ADDENDUM NO. 3

DATE: September 21, 2017
TO: All Bidders
FROM: ~~Boyce~~ H. Evans, Purchasing Agent
SUBJECT: Addendum No. 3 – North Central Street Streetscapes Project
BIDS TO BE OPENED: September 27, 2017, at 11:00 a.m. (Eastern)

STREETSCAPE IMPROVEMENTS
NORTH CENTRAL STREET
KNOXVILLE, TENNESSEE

DRAWN:	C.C.C.
CHECKED:	J.C.E.
JOB NO:	51130-63
SCALE:	1"=30'
DATE:	APRIL 2017
FILE NAME:	
DRAWING TITLE:	PAVEMENT MARKING AND SIGNING
DRAWING NO:	24

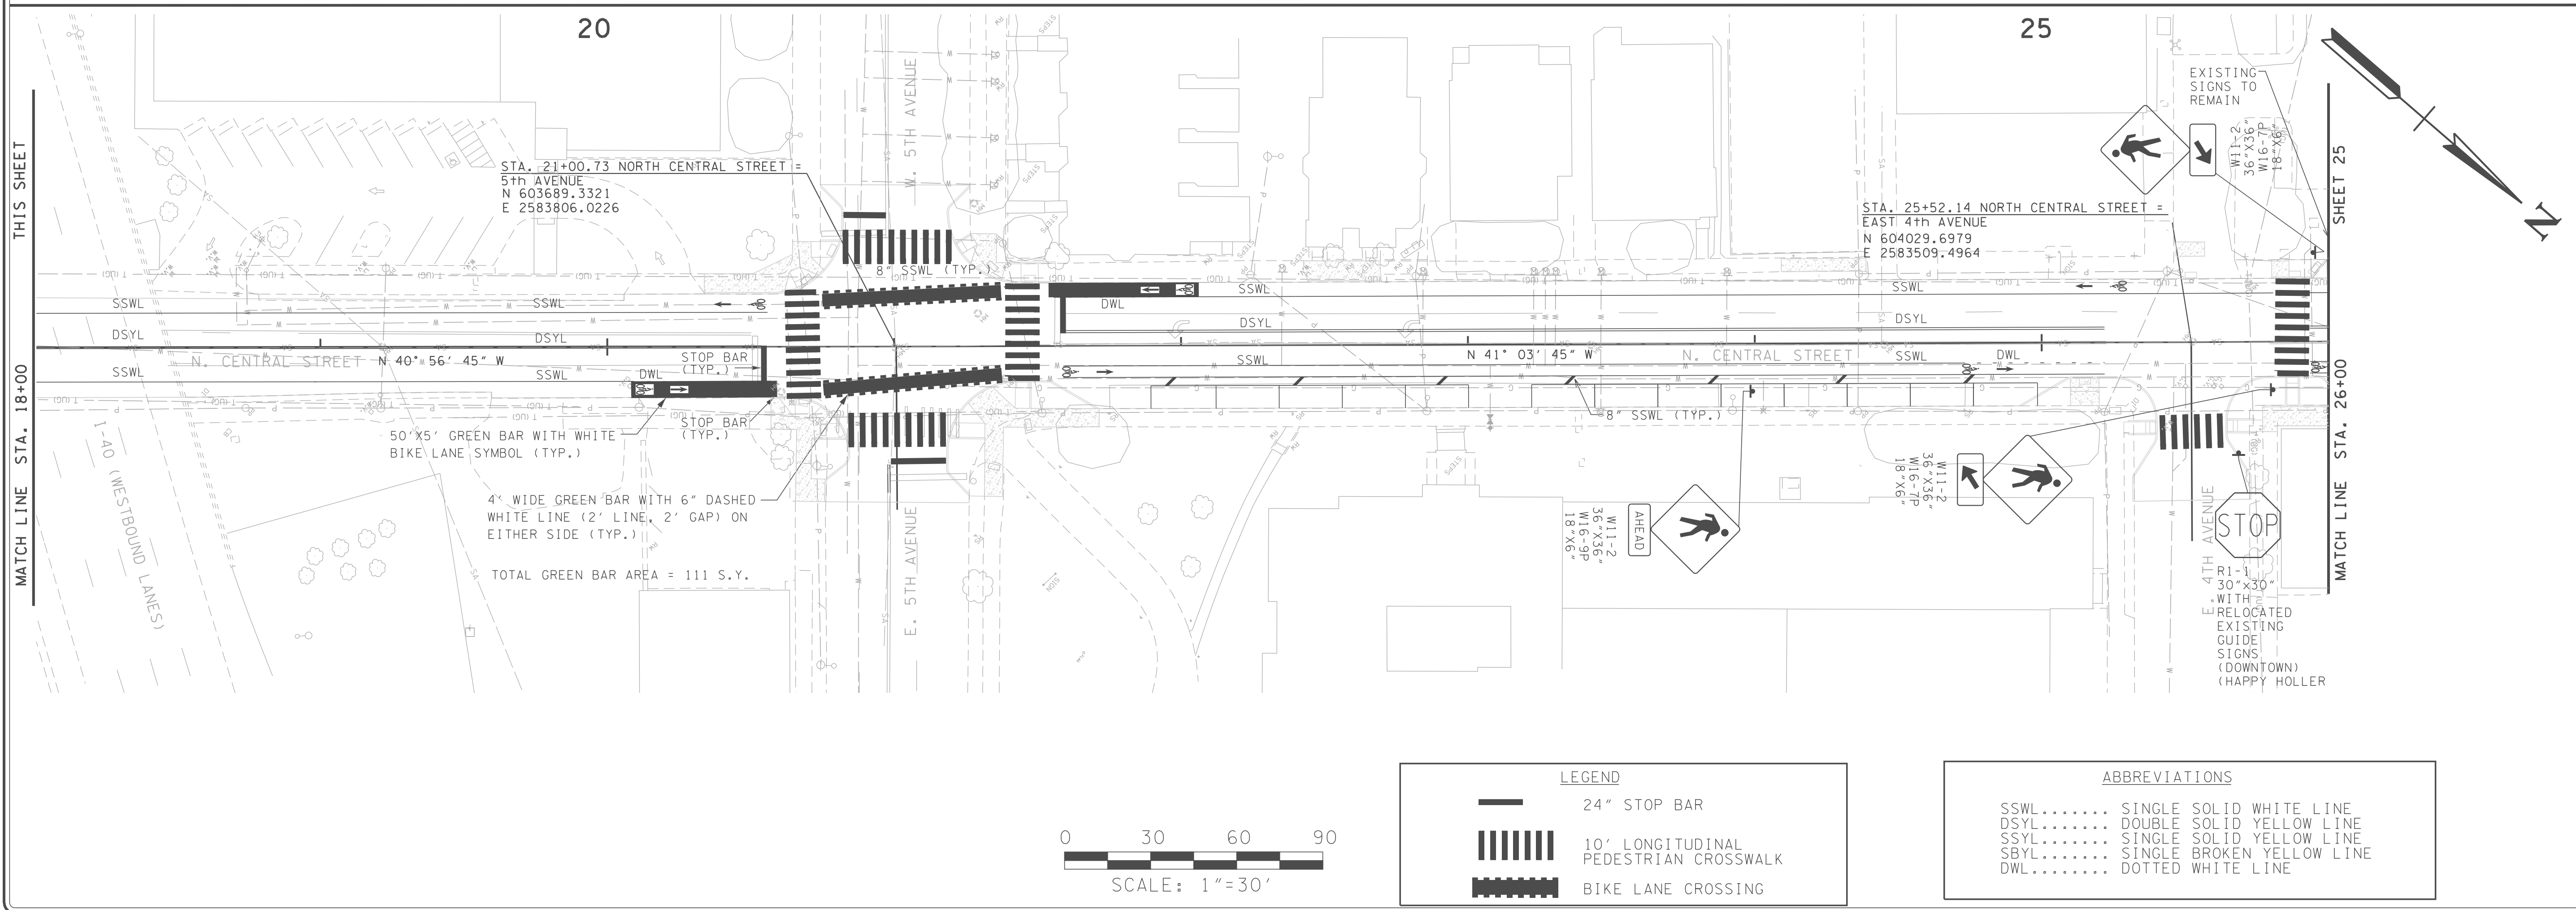
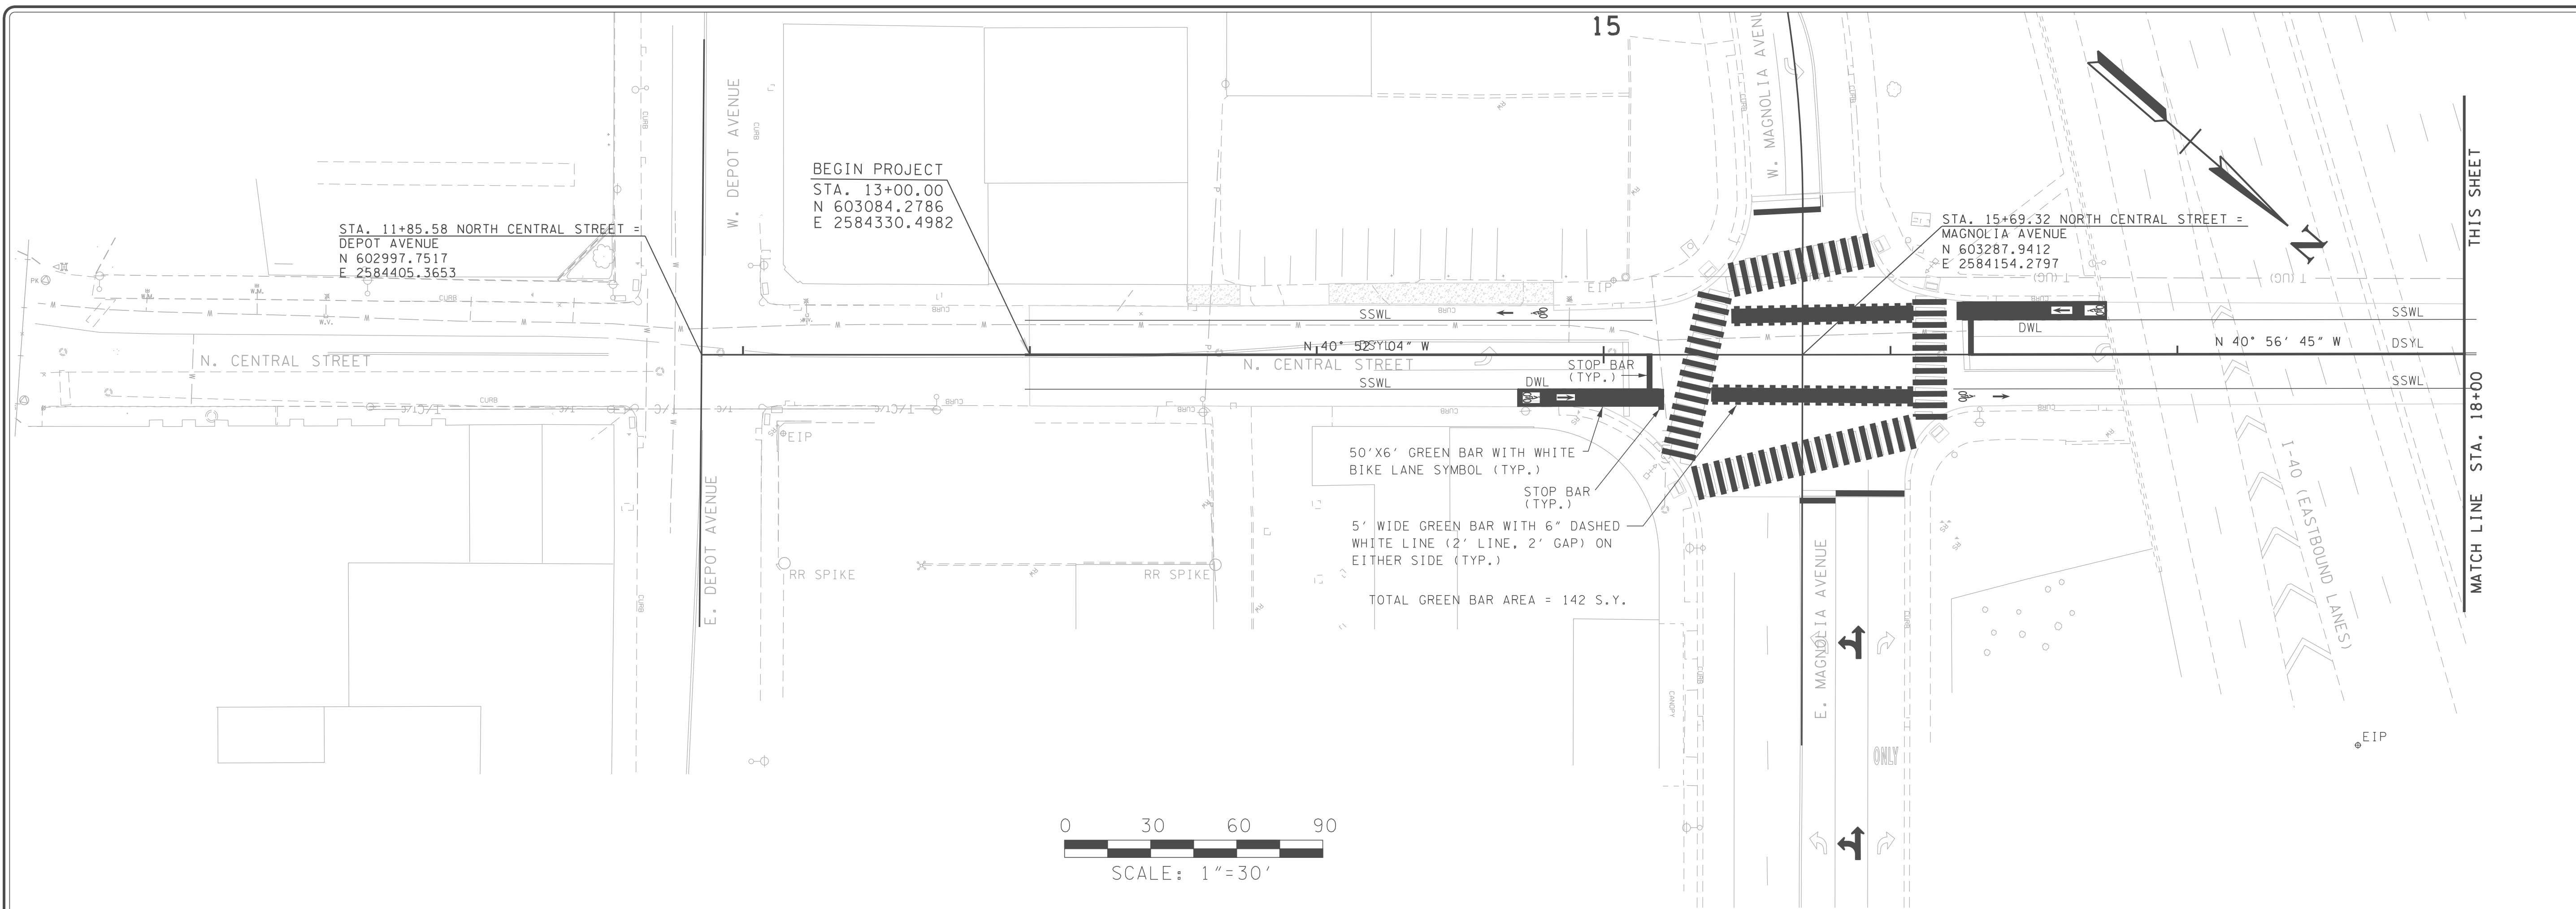
Question #19: What is the material for the Dotted White Line on either side of the Bike Lane Crossing shown on Drawing No. 24?

Question #21: Is there a Typical Drawing for the Bike Symbol within the Green Bar shown on Drawing No. 24?

Response #19: See response #17 above.

Response #21: TDOT Standard Drawing T-M-11, Signing and Pavement Markings for Bicycle Lanes or Routes.

TS6.00

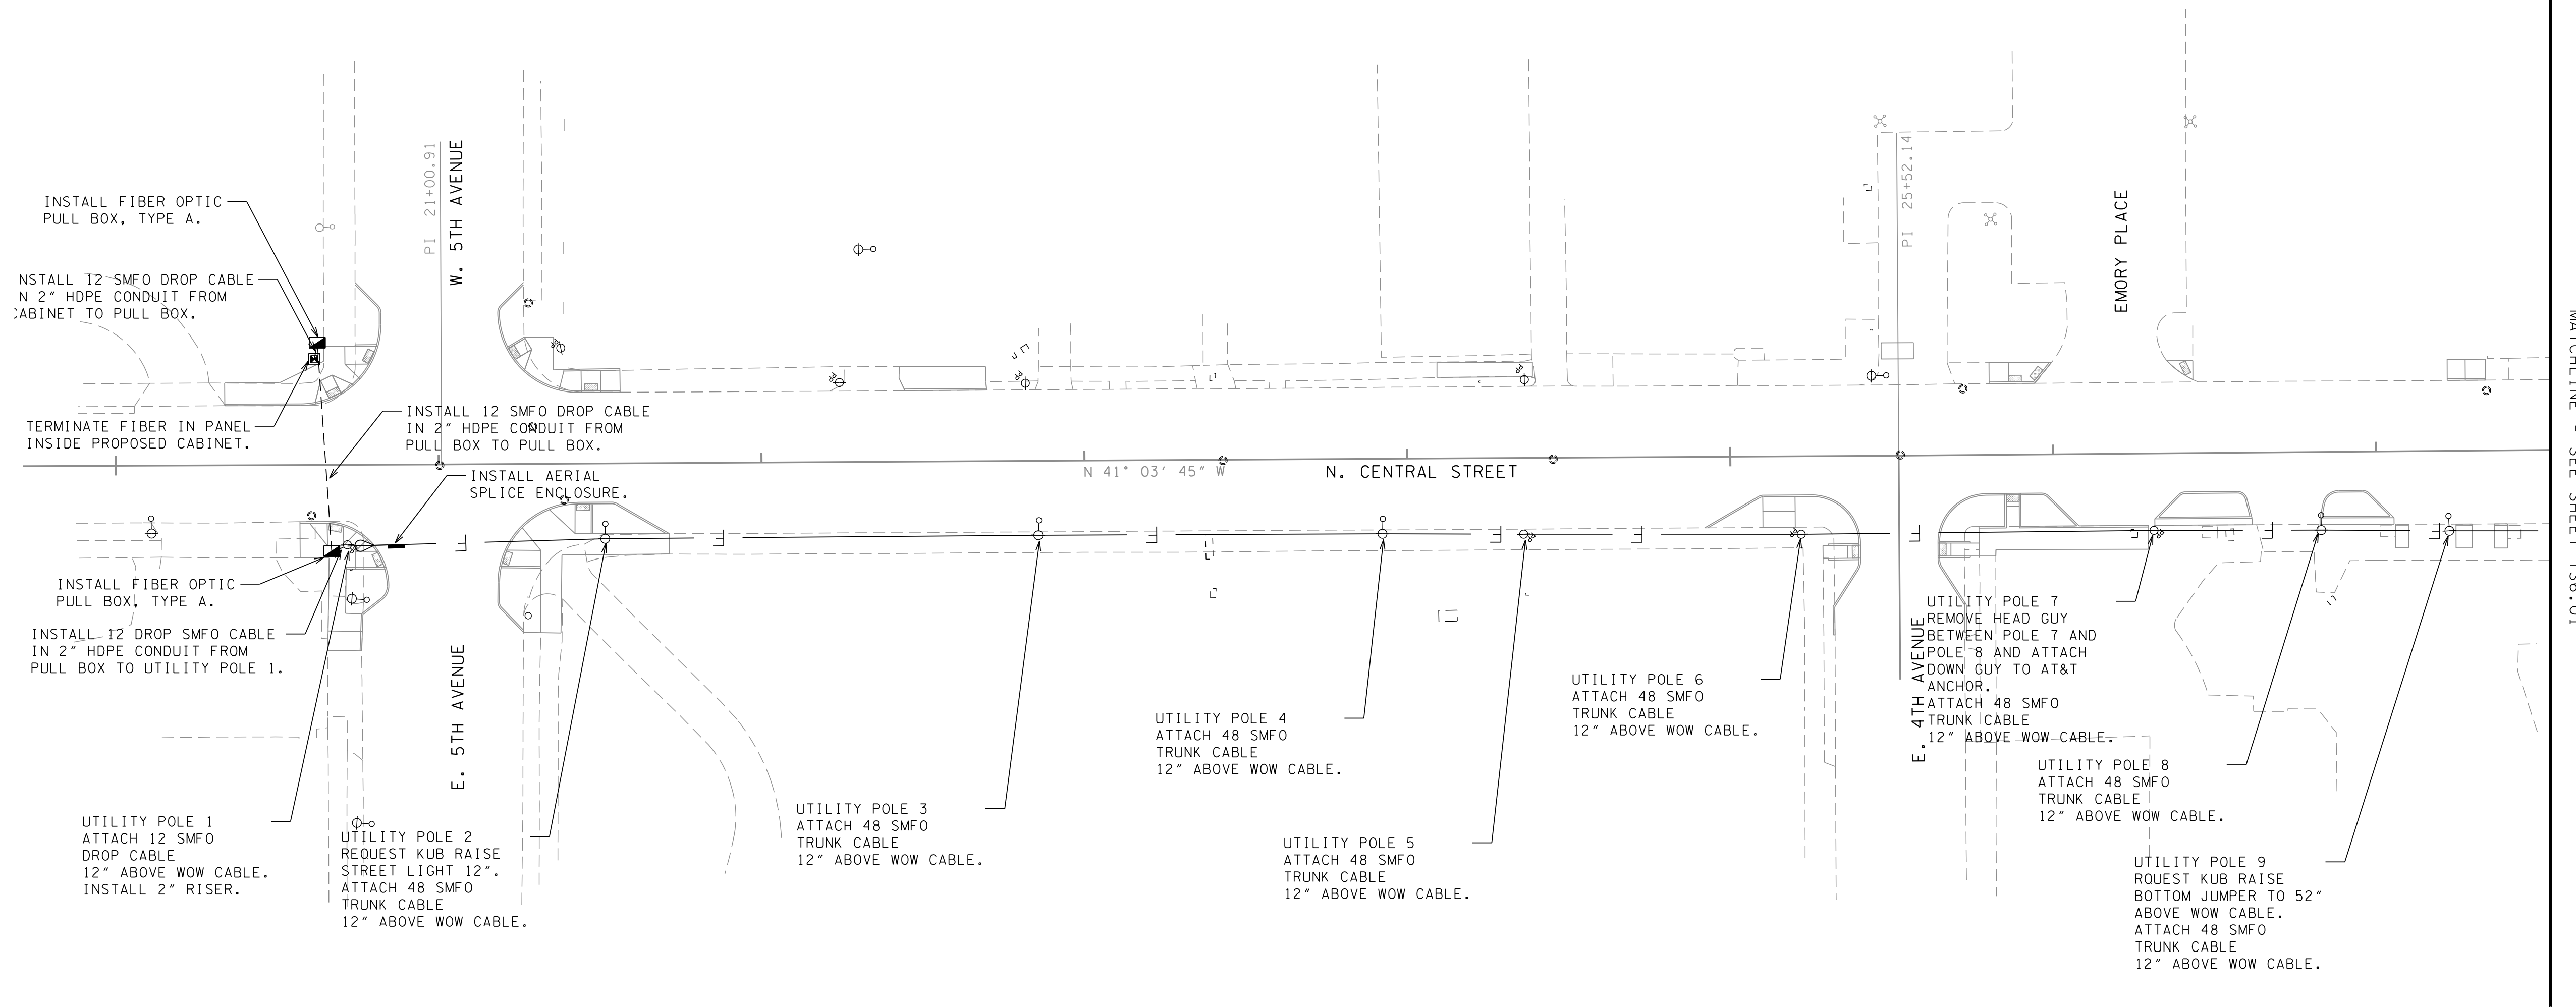
REVISIONS	DATE
CHANGED FIBER DROP CABLE FROM 6 SM TO 12 SM	09-18-17
REVISED AS PER TOOT REVIEW COMMENTS	05-06-17
